2. **760 TOLMIE AVENUE**

# Report

**To:** Mayor and Council  
**From:** Lindsay Chase, Director of Planning  
**Date:** October 7, 2024  
**Subject:** Rezoning and Development Permit Application  
**File:** DPR01020; REZ00728 • 760 Tolmie Avenue

Figure 4: Phase 1 (left) Oak Street Frontage Landscape Plan Phase 2 (Right) Oak Street Frontage Landscape Plan, provided by Durante Kreuk Ltd. Landscape Architects.

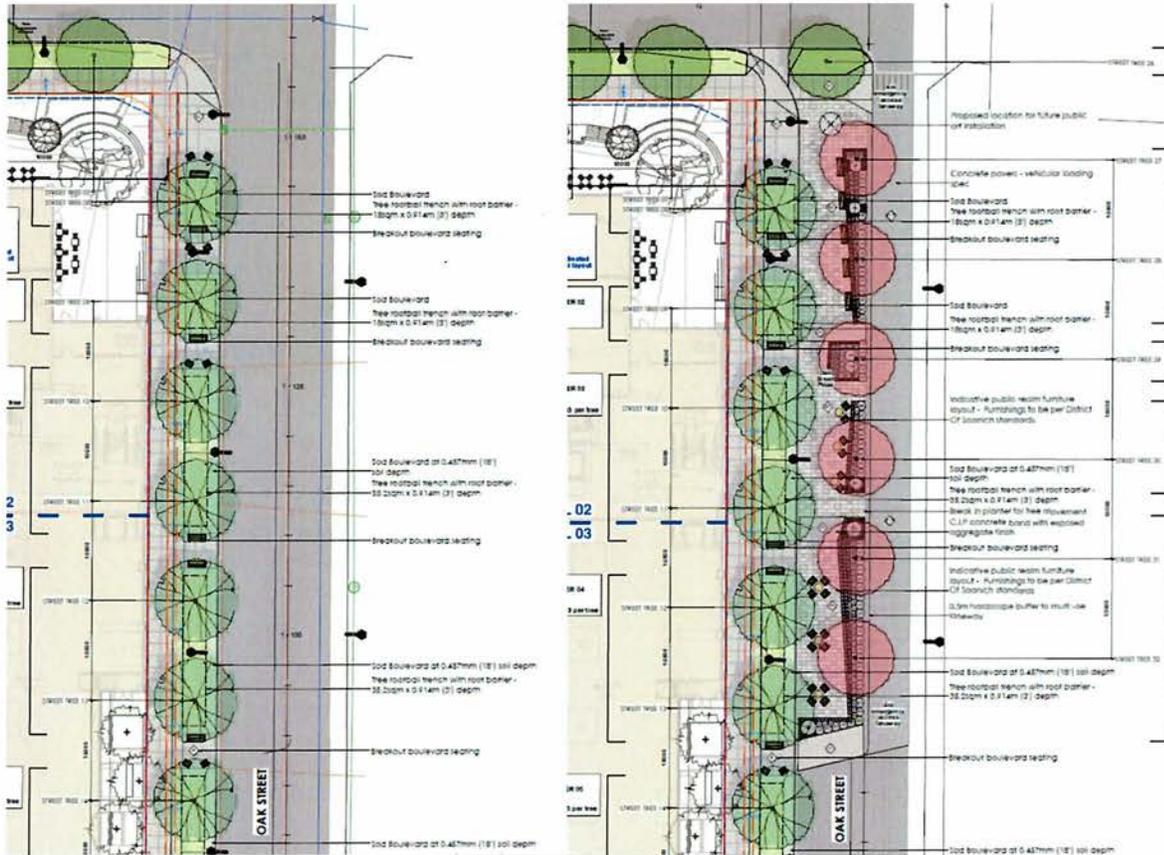
frontage improvements, see Figure 4. The second phase would entail the build out of the plaza which would be completed at a later date by others. The applicant has proposed to provide a financial contribution towards the future build out of the plaza.
